PLANNING & ZONING COMMISSION

Regular Meeting Agenda
CITY OF PARKVILLE, MISSOURI
Tuesday, August 10, 2021 5:30 PM
City Hall Board Room

Proposal: Application for Zoning Map Amendment and Application for Preliminary Development Plan for Platte 38, a planned residential development consisting of an apartment/condominium building and duplexes on 38.24 acres, more or less, generally located to the north of Walnut Creek Acres No 4 subdivision, to the south of The Deuce at The National Golf Club of Kansas City, and to the west of The National 7th subdivision between N Crooked Rd and S National Dr. in Unincorporated Platte County, MO 64152.

**RE: City of Parkville staff review comments – Platte 38 Preliminary Development Plan
(prepared by Renaissance Infrastructure Consulting; dated April 9, 2021)**

TREE LANDSCAPE PLAN
1" = 60'-0"

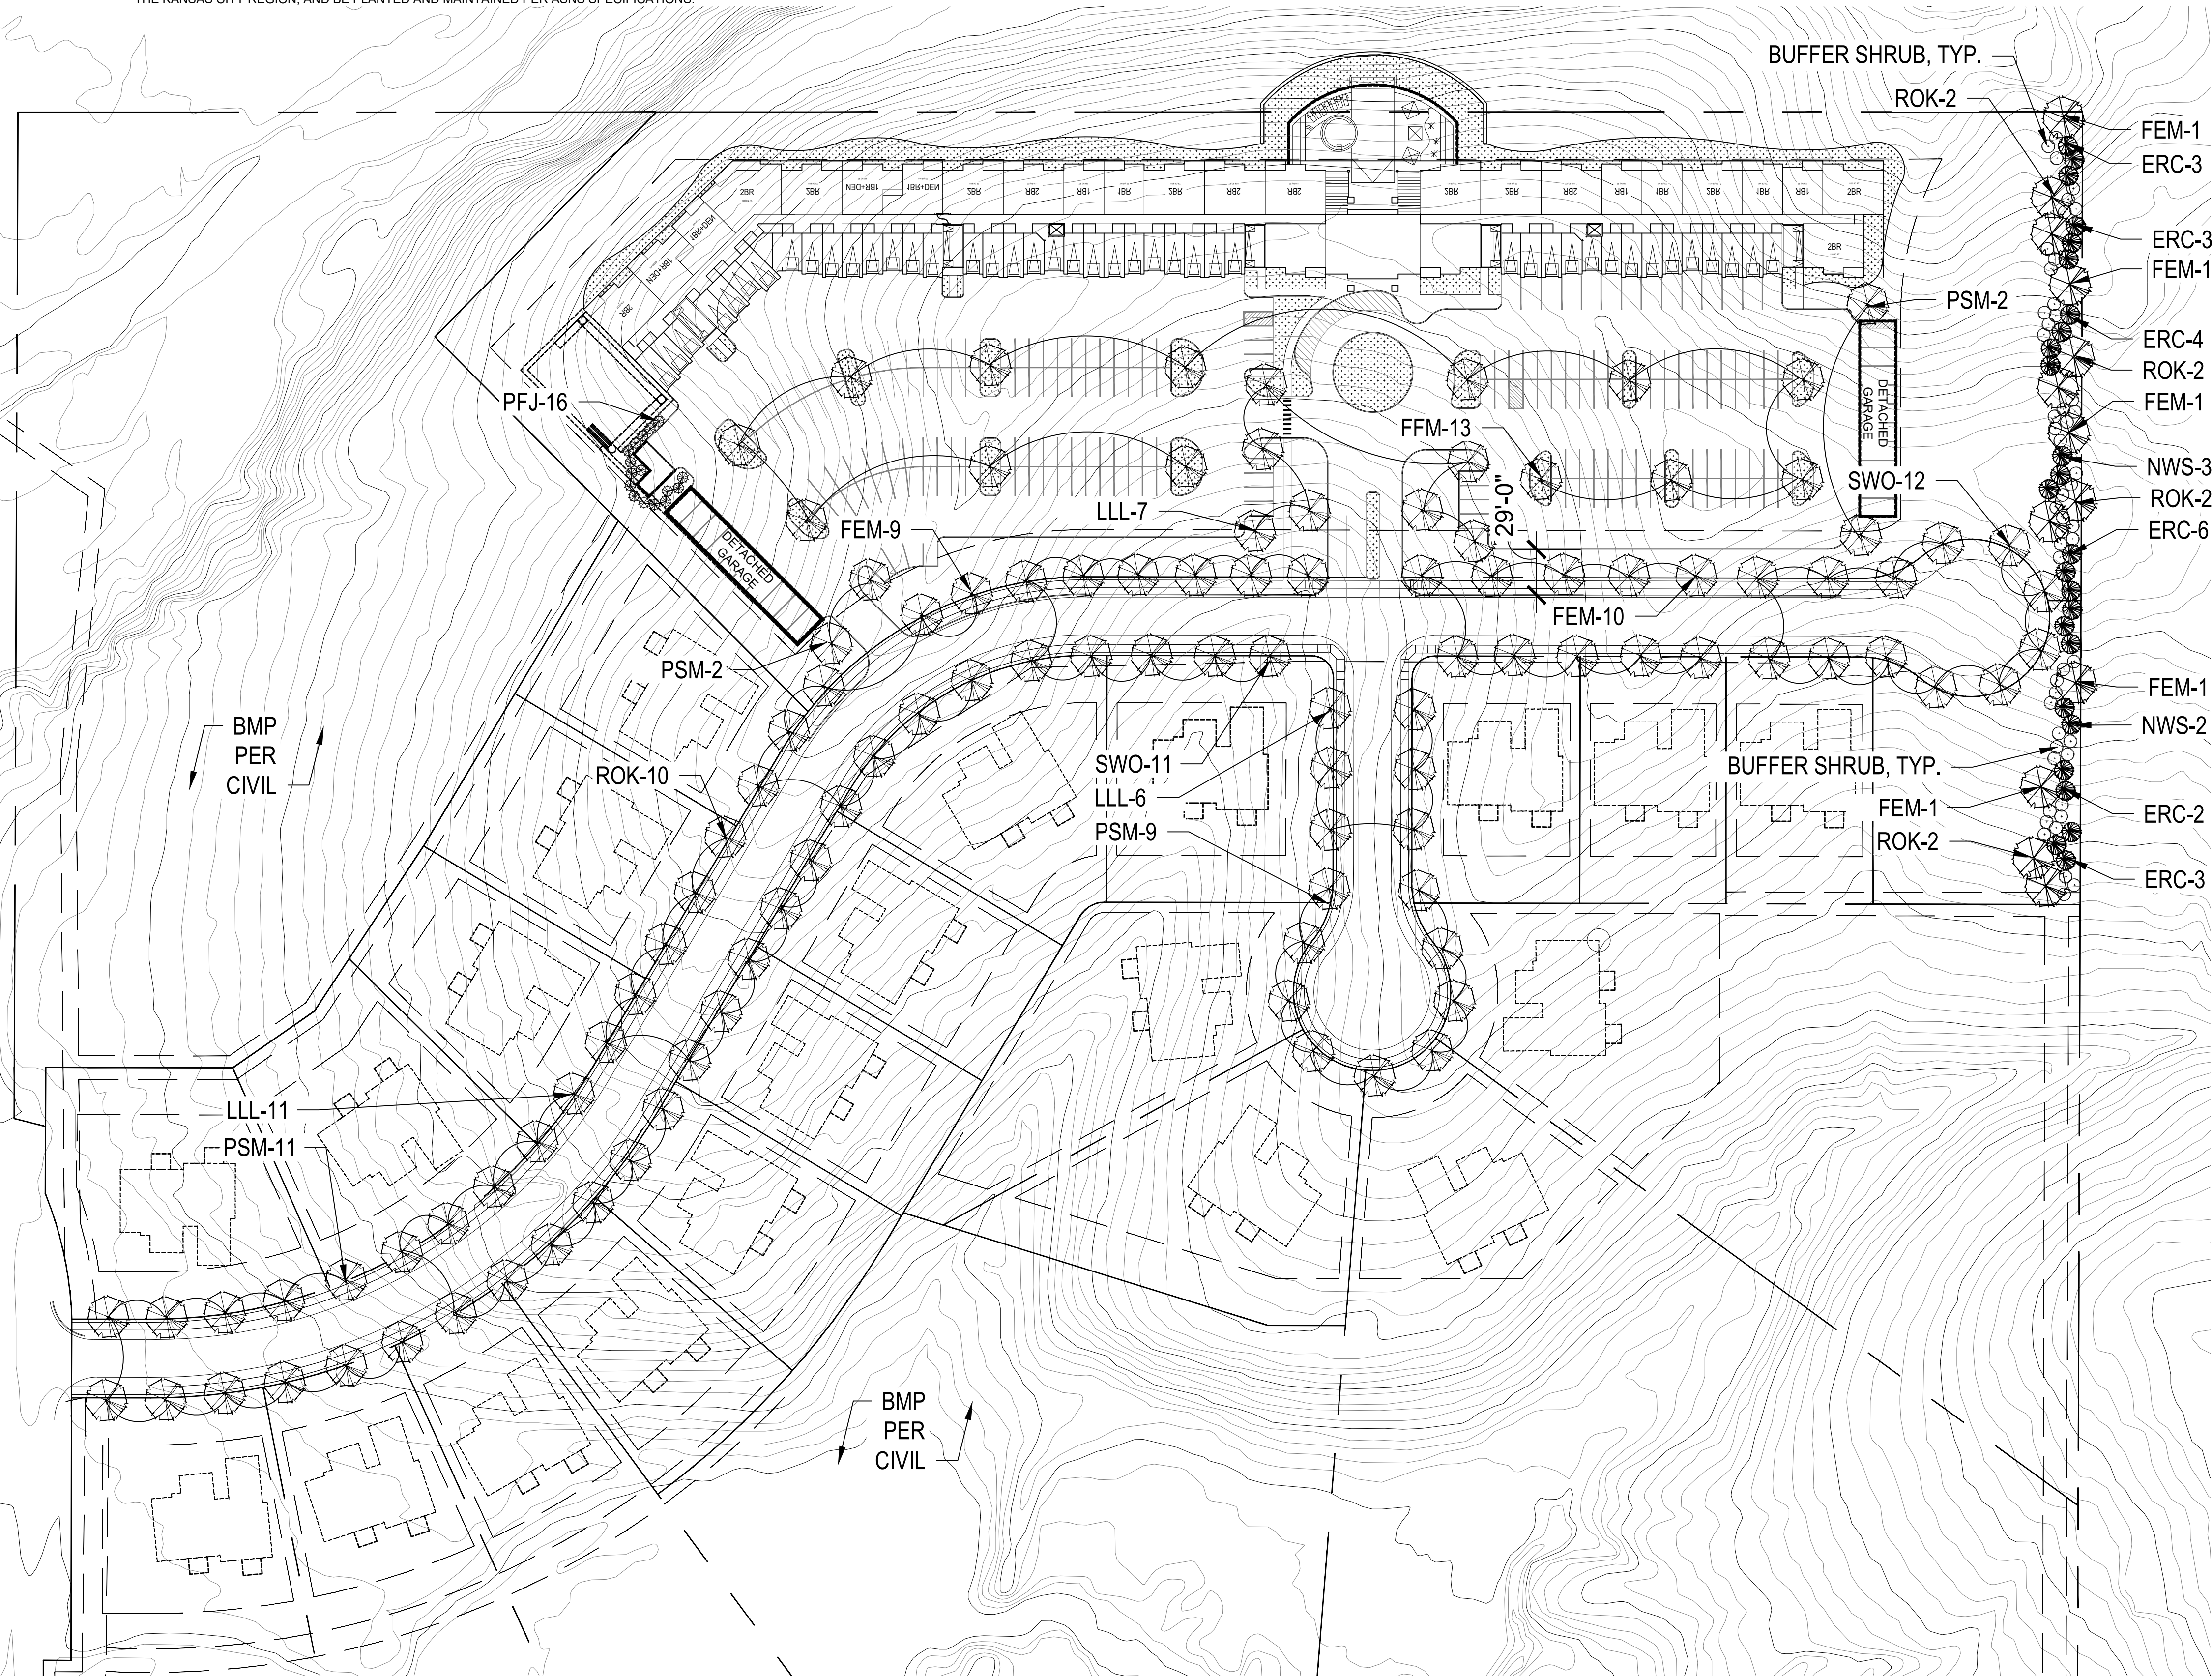
Tree Landscape Plan (Sheet L1.00)

[Note has been added to sheet L1.00.](#)

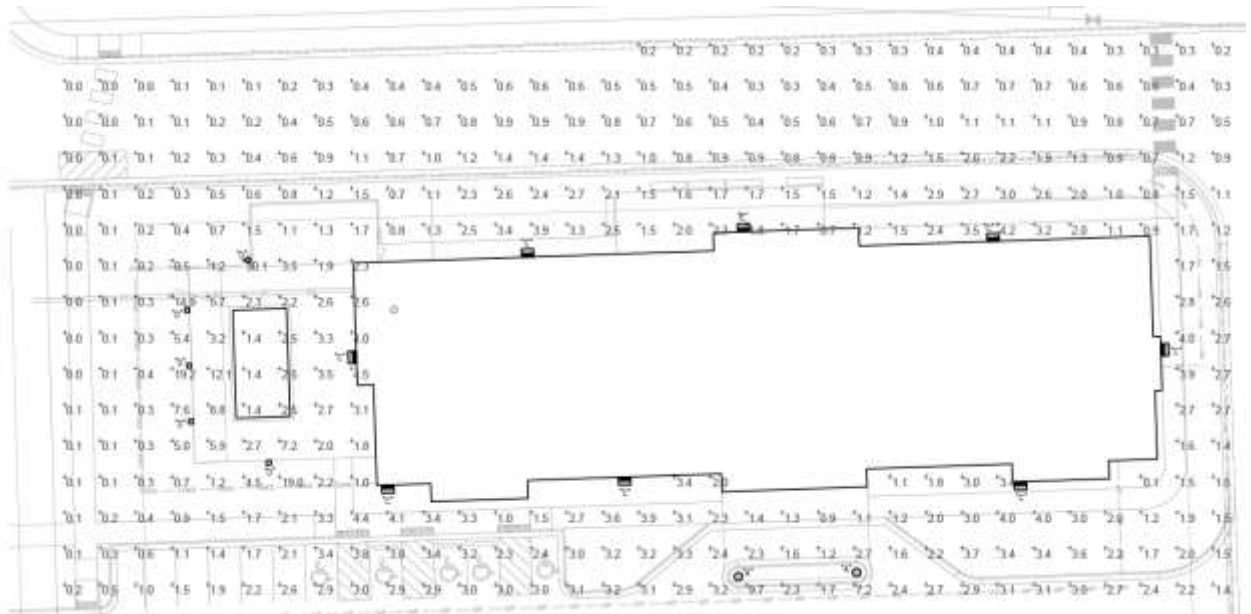
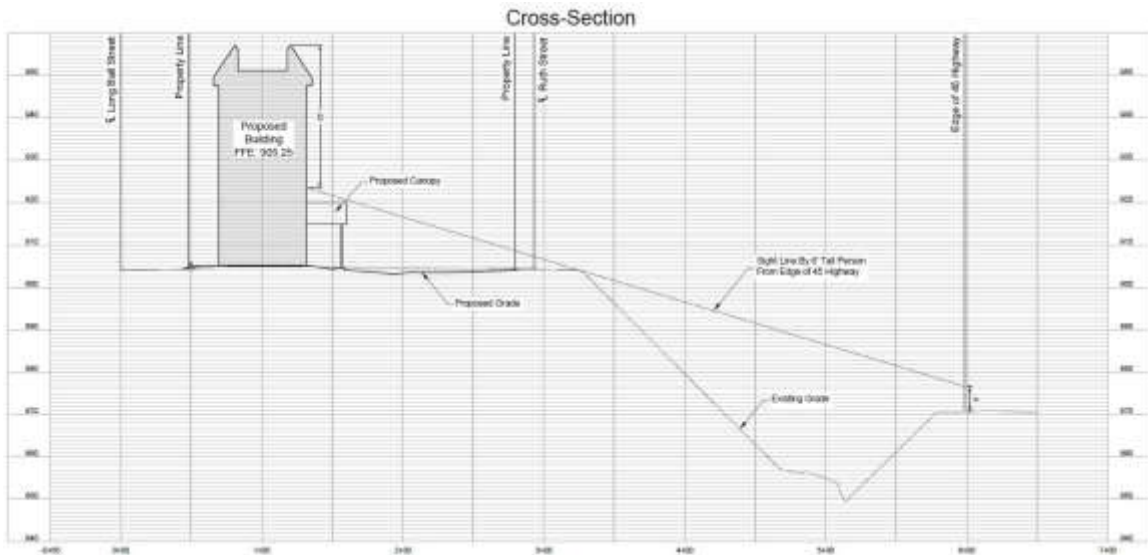
9. **Photometric Plan Sheet** – Please include a lighting plan sheet, in conformance with Section 407.040, showing the location, dimensions/specifications (e.g., mounting height), shielding standards/type and photometric general footprint and impact of lighting throughout the development and on any adjacent properties. See images below as examples.
